SERVICE BULLETIN 38

SUBJECT: LOCATION OF FLAP CONTROL ASSEMBLY

APPLICATION: All Glasair III aircraft, all Glasair II TD, and FT Aircraft.

FIGURE (A)

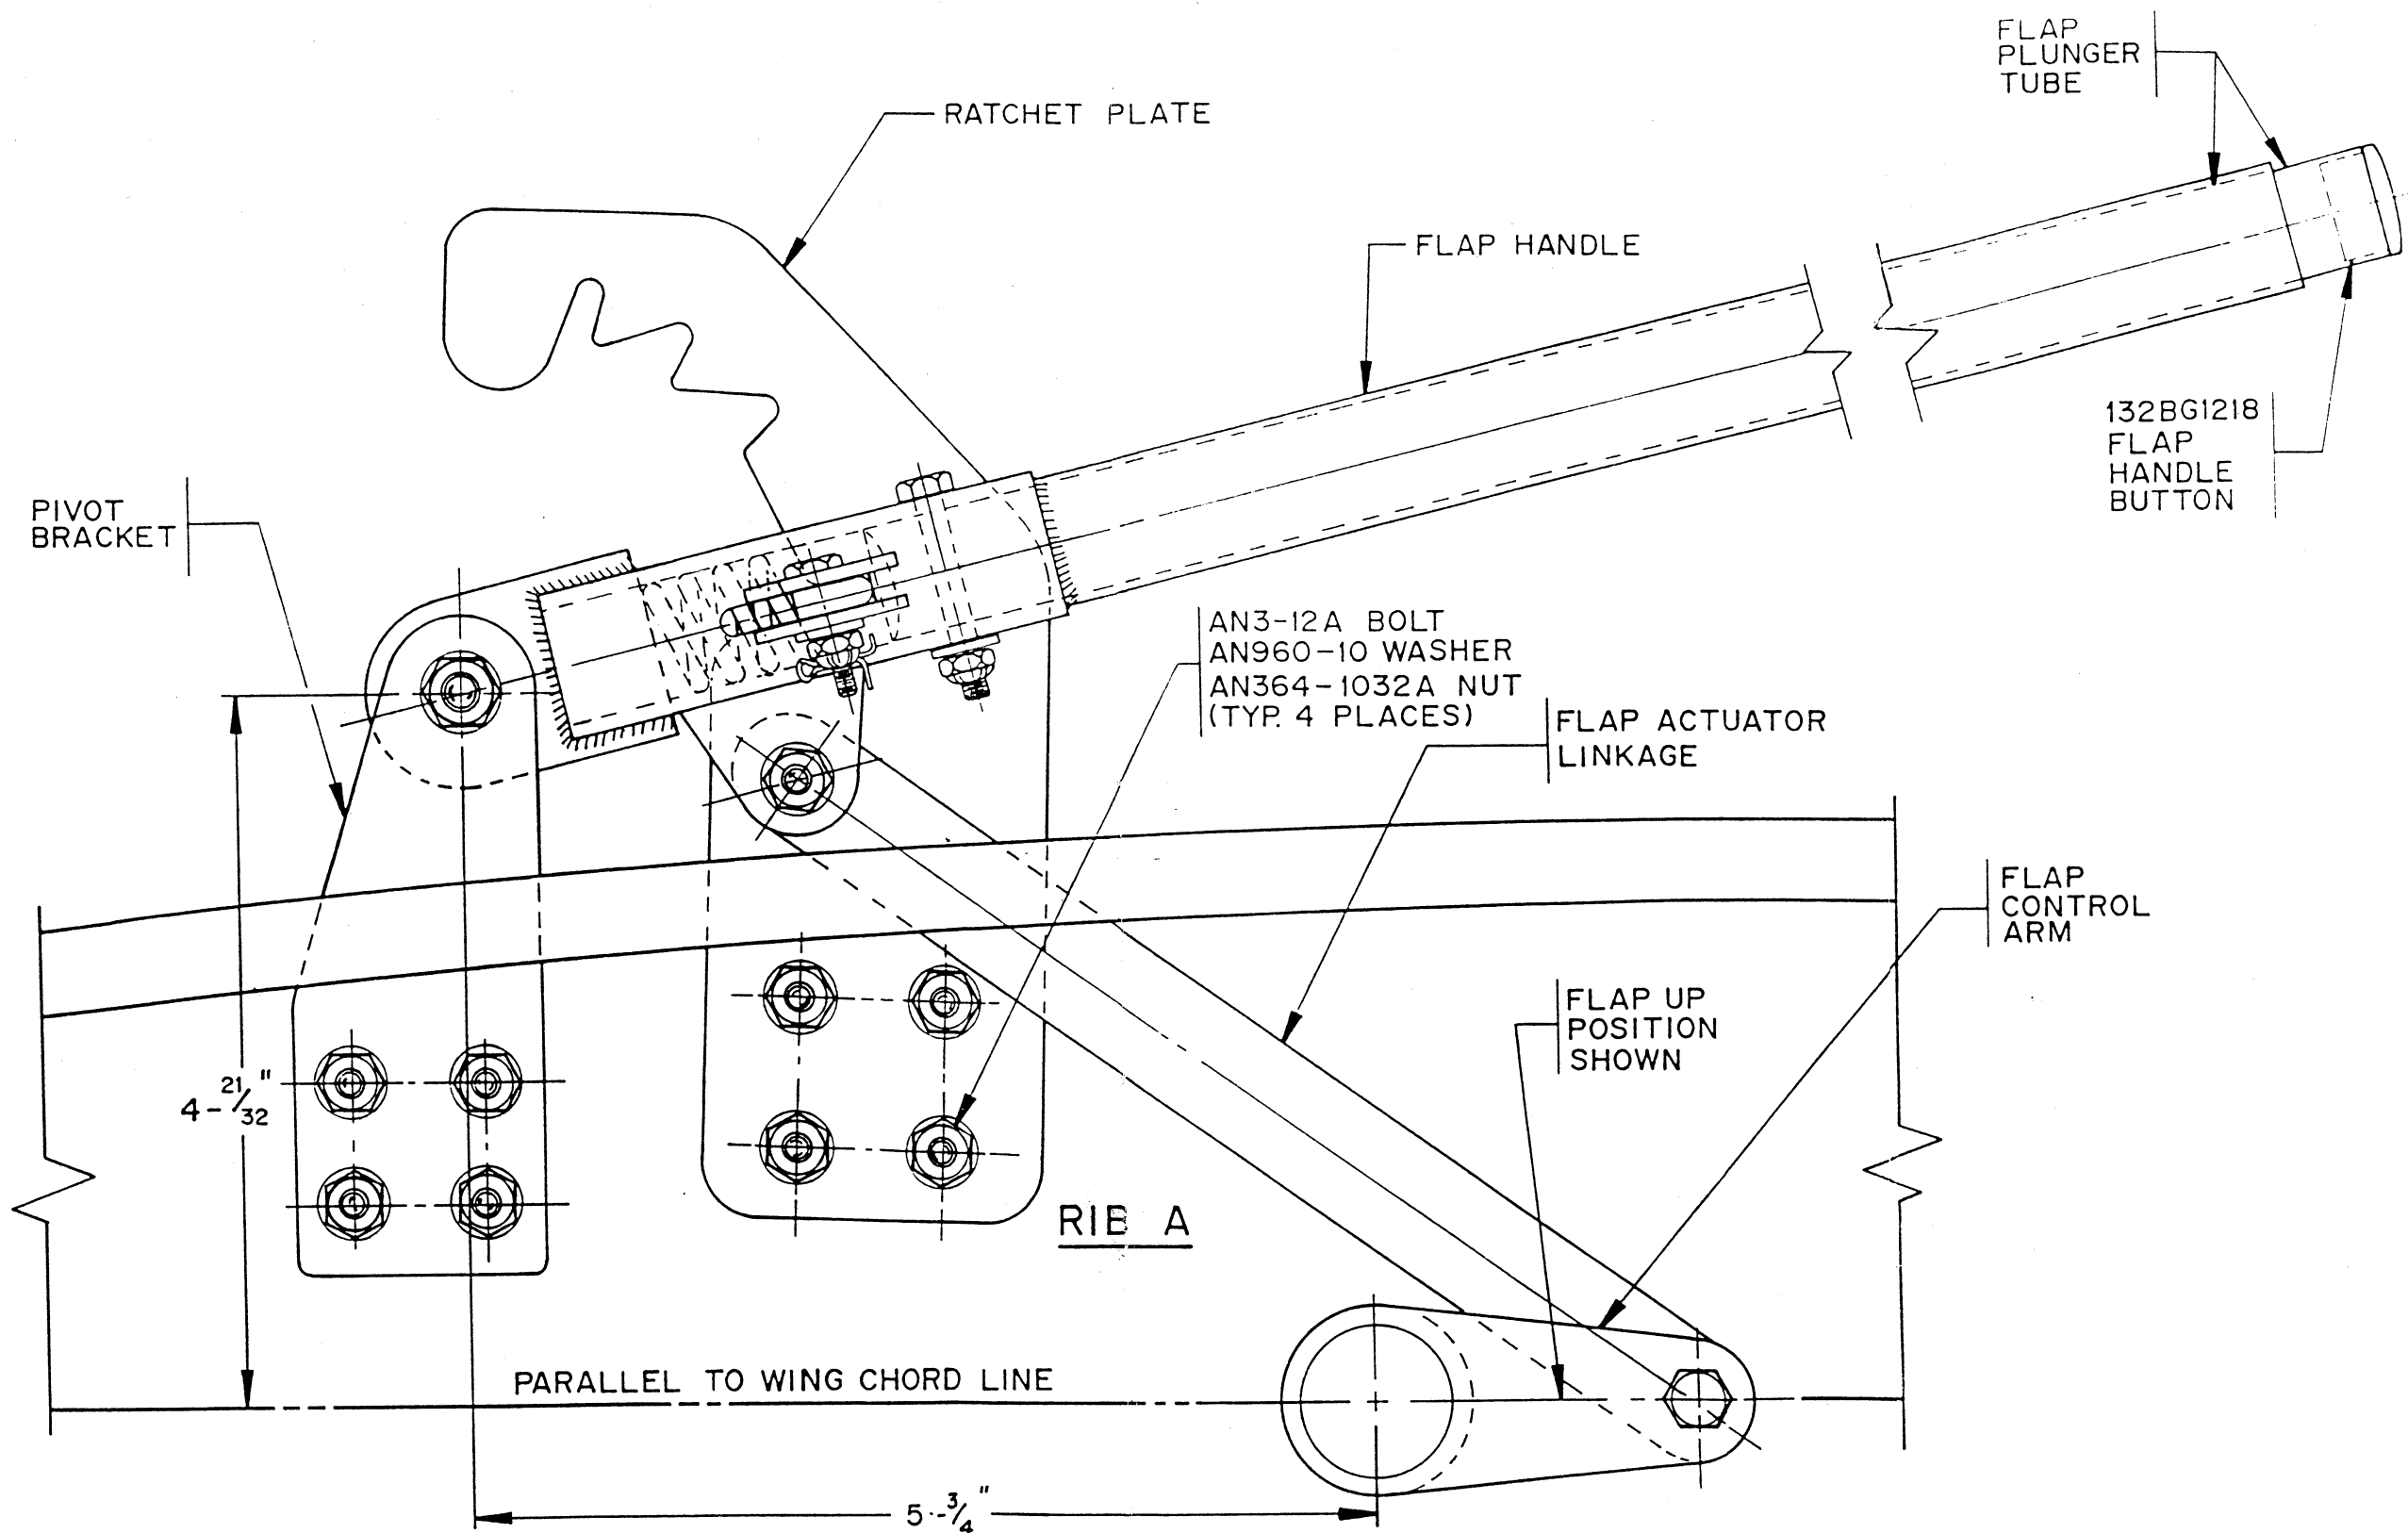
Description: The locating dimensions shown for the Flap Actuating Mechanism in the Manual References listed above, are incorrect. The proper locating dimensions are shown in the enclosed FIGURE (A). The correct dimensions have been incorporated in the Glasair II RG Assembly Manual and will be incorporated in the next revision for the remaining manuals.

FLAP CONTROL ASSEMBLY
FLAP UP (RETRACTED) POSITION
